ILLINOIS DEPARTMENT OF TRANSPORTATION
F.A.I. 90/94 (DAN RYAN EXPRESSWAY)
63RD STREET TO GARFIELD BLVD (NB LOCAL LANES)

REVISIONS	
NAME	DATE
ADDENDUM 1	7/27/06

**PROPOSED TYPICAL SECTIONS
NORTHBOUND LOCAL LANES**

CANTILEVER SIGN STRUCTURES
DRILLED SHAFT
ALUMINUM TRUSS & STEEL POST

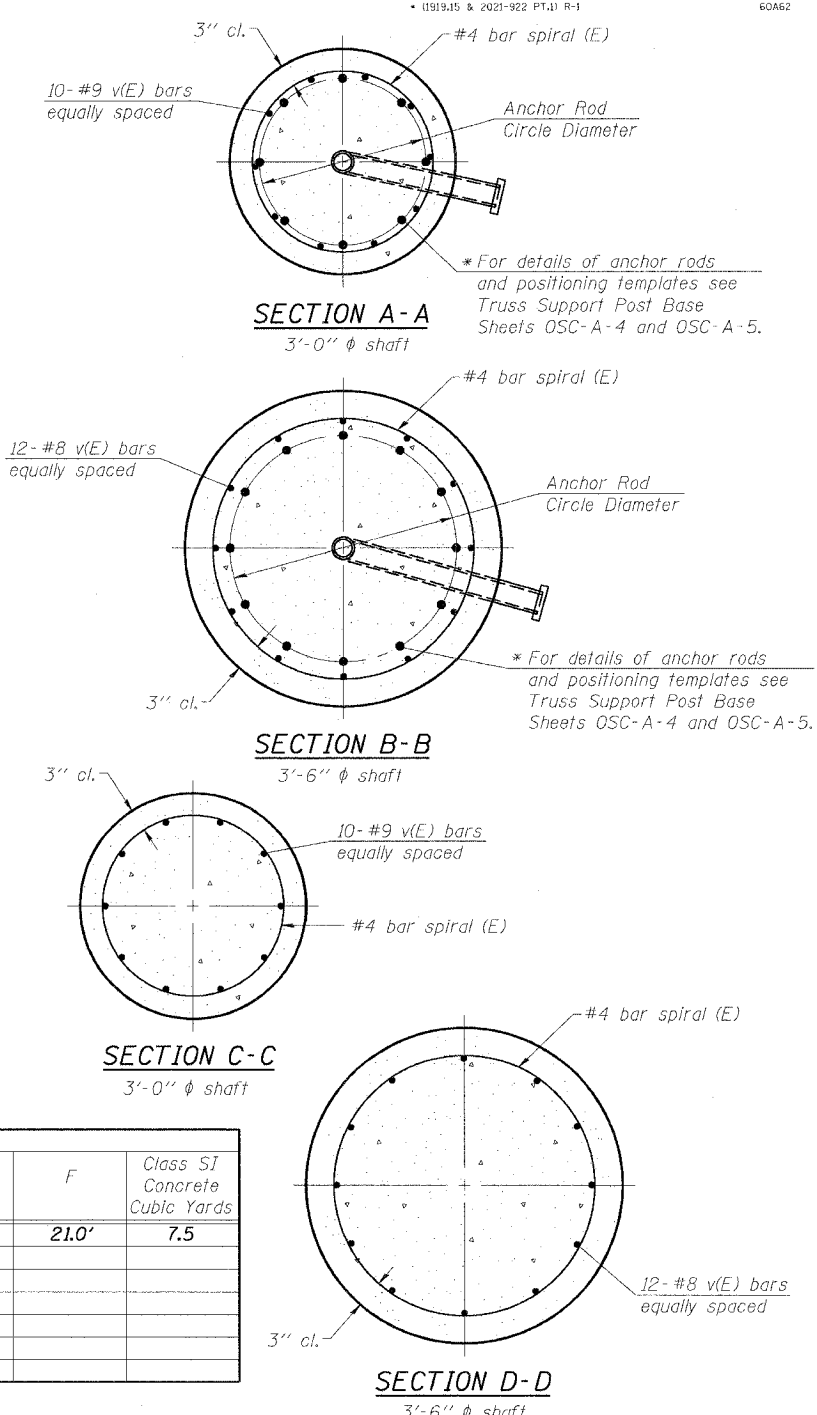
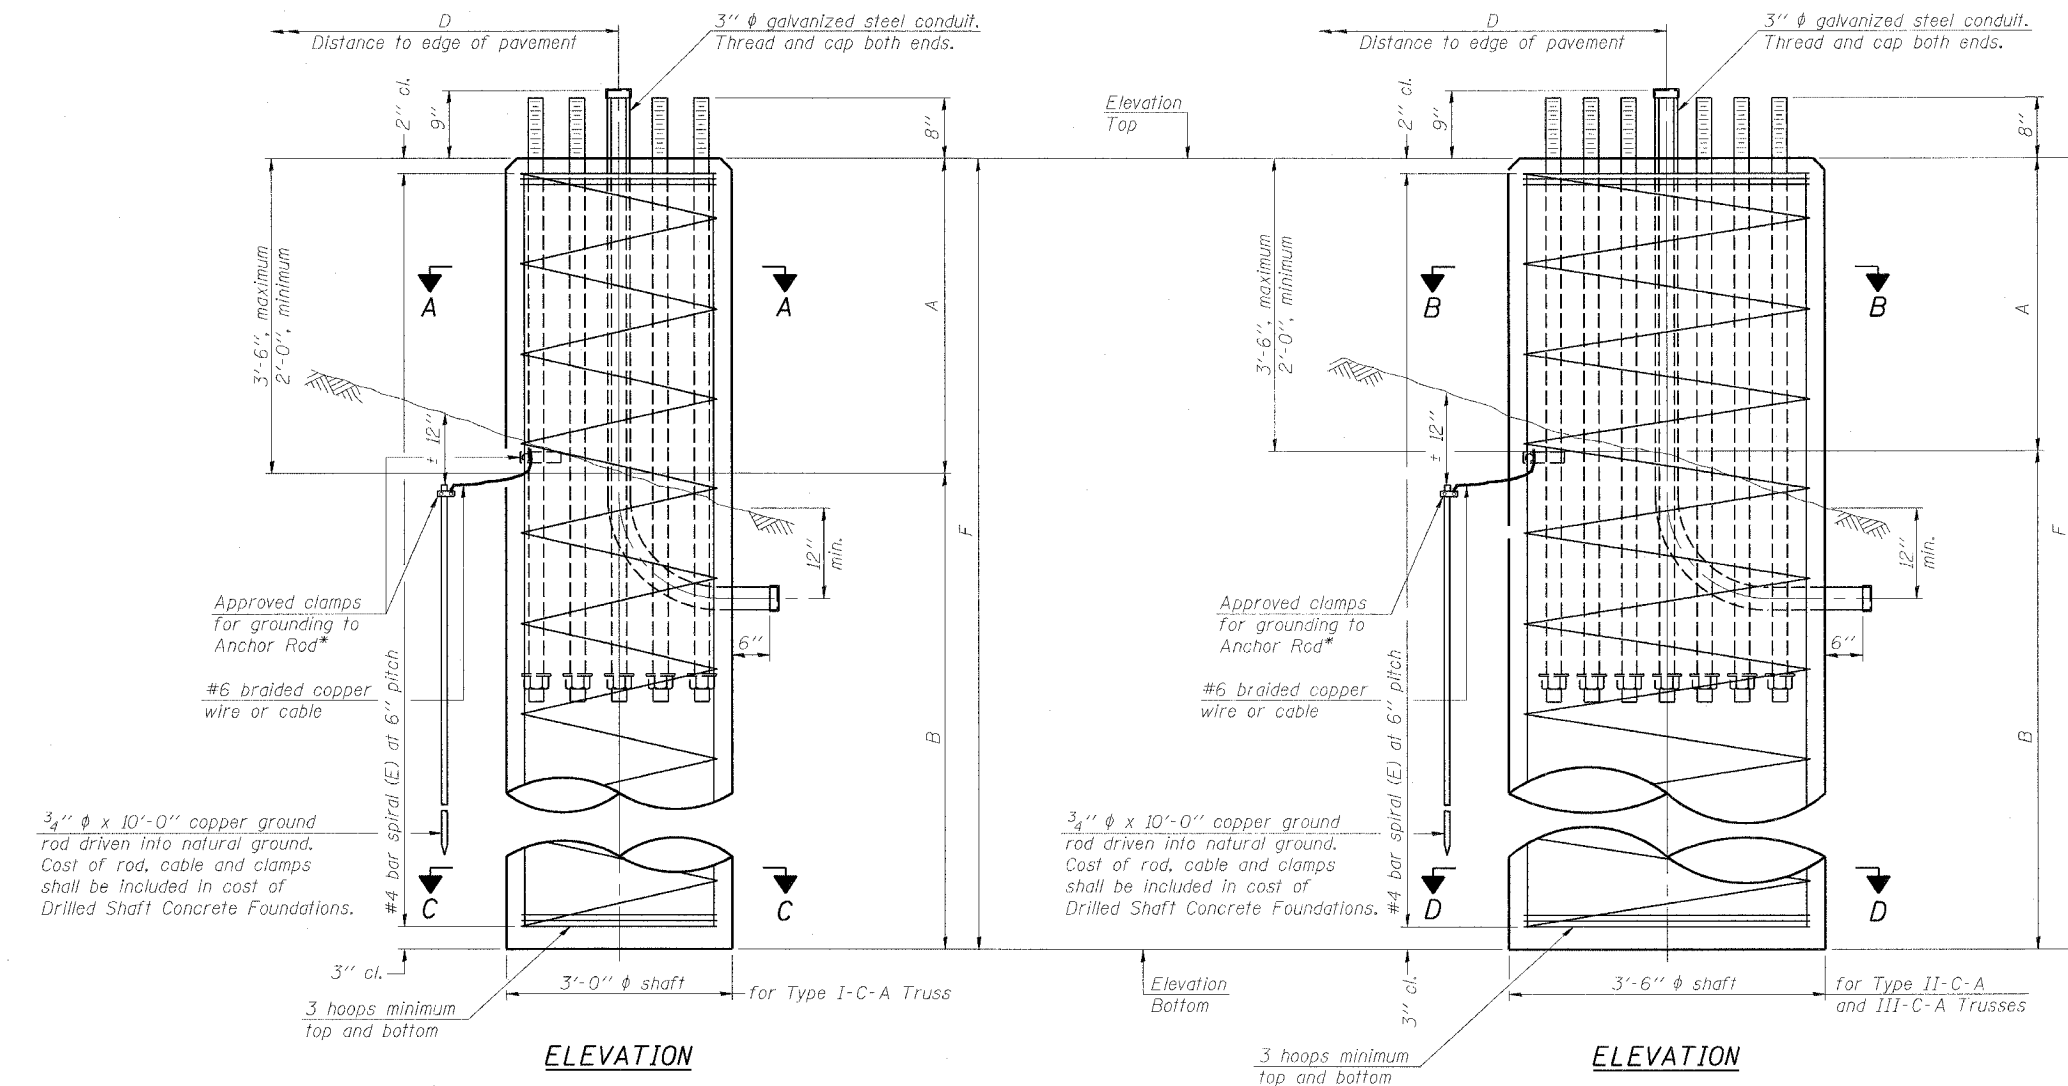
NUMBER	REVISION	DATE
1	Shaft Diameter - (in) to (ft)	7/21/06

**OVERHEAD SIGN STRUCTURES
GENERAL PLAN & ELEVATION
ALUMINUM TRUSS & STEEL SUPPORTS**

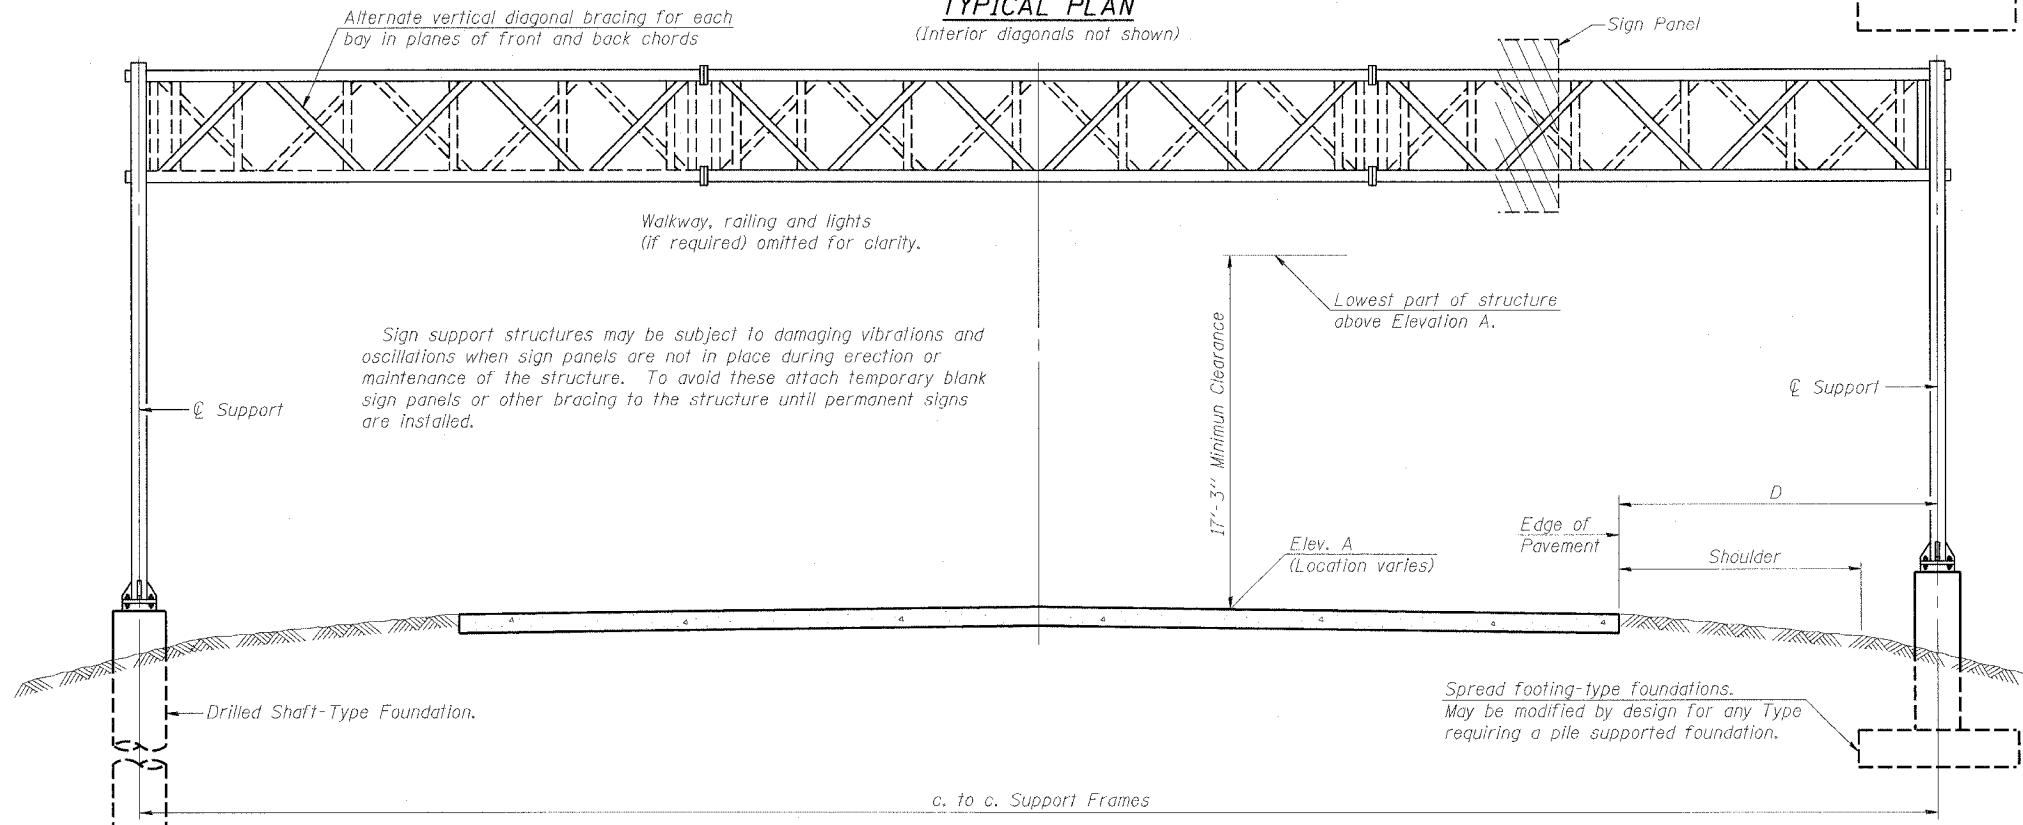
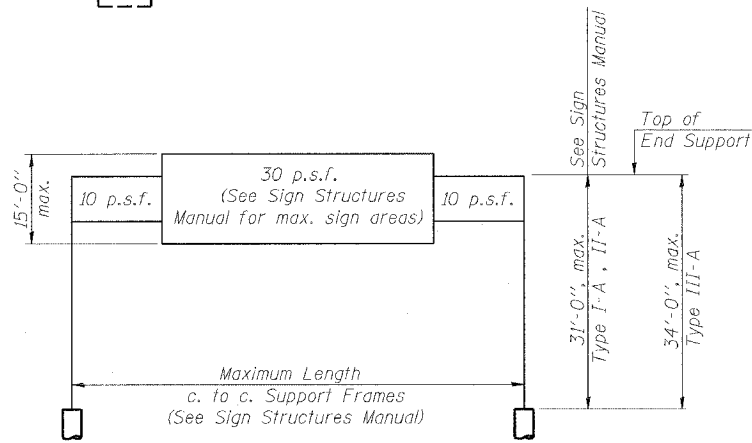
NUMBER	REVISION	DATE
1	Total Bill of Material	7/21/06

**OVERHEAD SIGN STRUCTURES
ALUMINUM WALKWAY DETAILS**

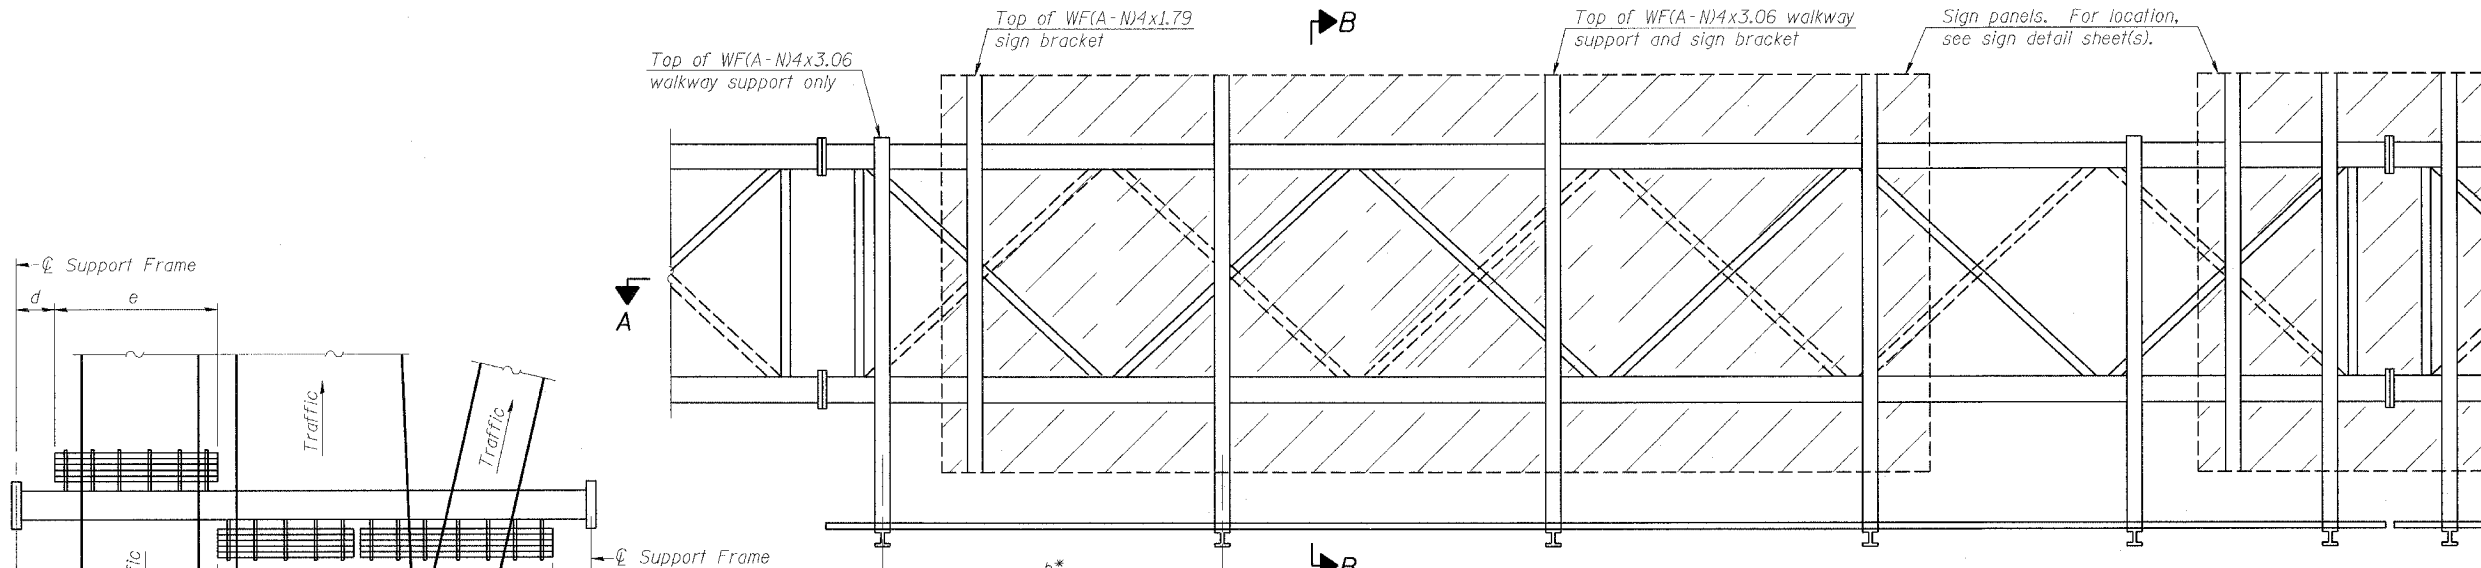
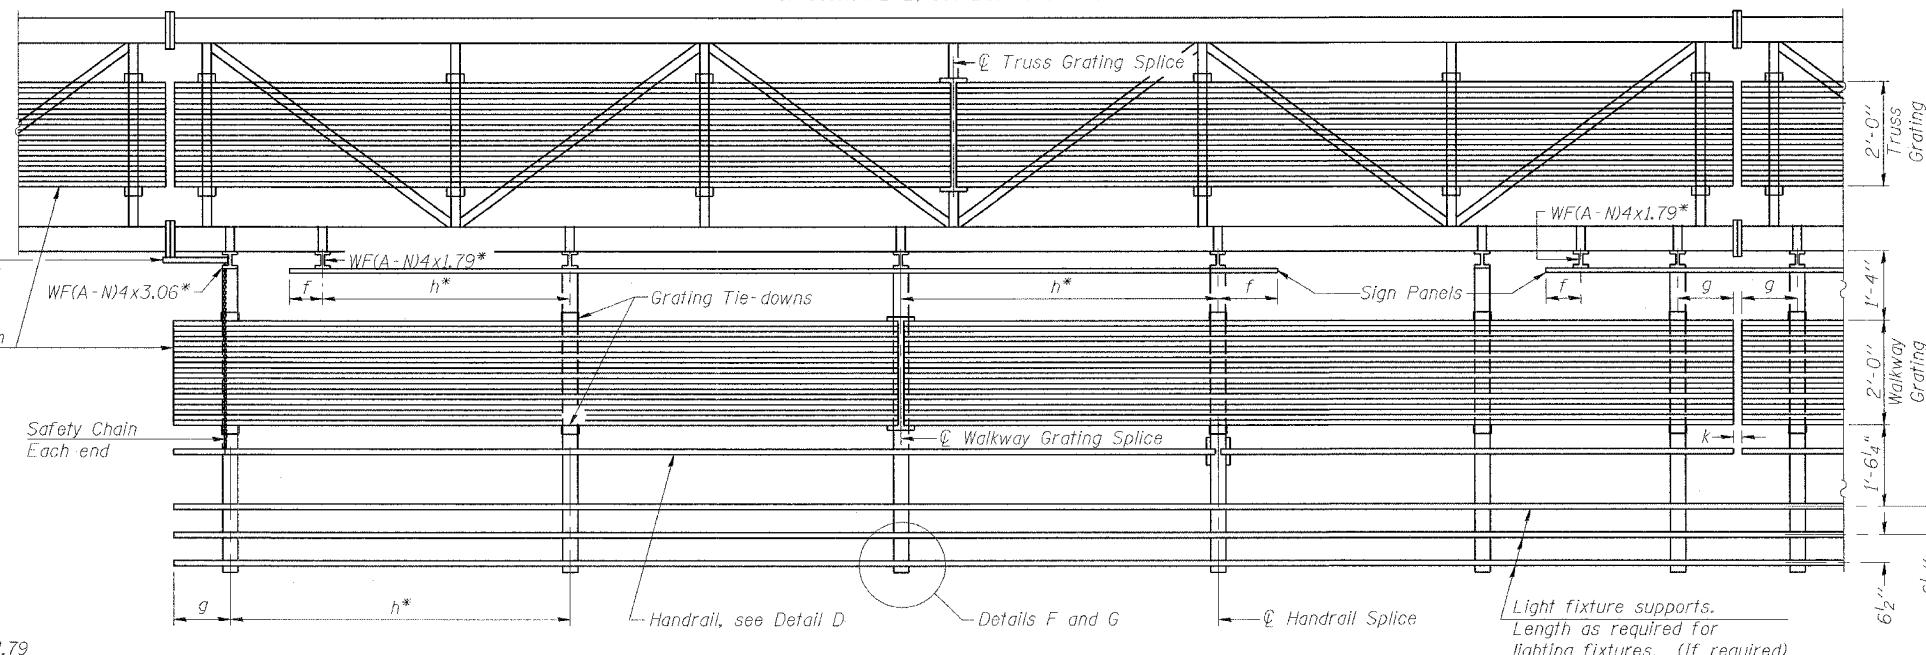
NUMBER	REVISION	DATE
1	Dimensions b and c	7/21/06

Structure Number	Station	a	b	c	d	e	Walkway Grating and Handrail Lengths
ISO161094L058.8	4421+30.00	7.87'	46.0'	10.13'	---	---	46.0'

OSS-31

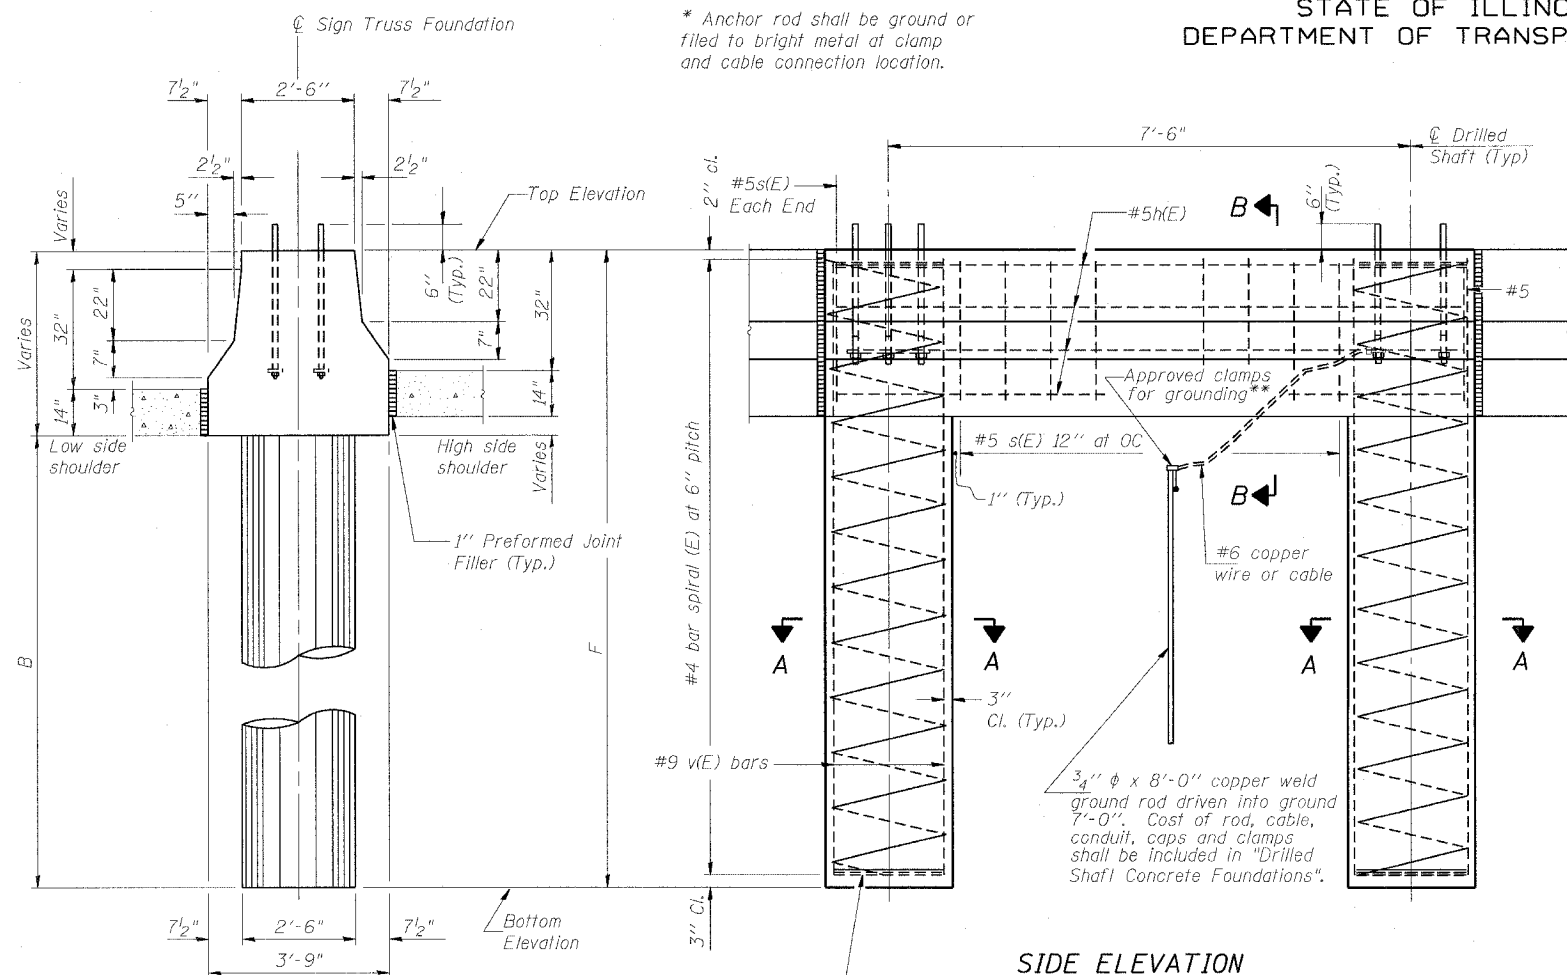
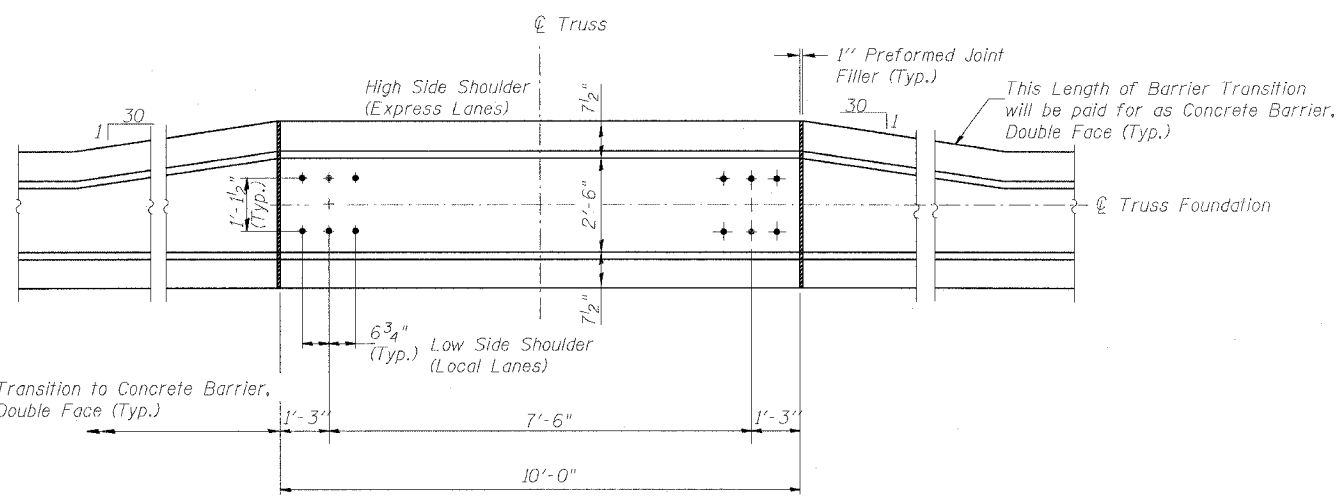
NUMBER	REVISION	DATE
1	Elevation Bottom, B and F Dimensions Class SI Concrete	7/21/06

Structure Number	Station	Left Foundation				Right Foundation				Class SI Concrete (Cl. Yds.)
		Elevation Top	Elevation Bottom	B	F	Elevation Top	Elevation Bottom	B	F	
ISO161094L058.8	4421+30.00	4.29'	-13.32'	13.50'	17.61'	----	----	----	----	9.8
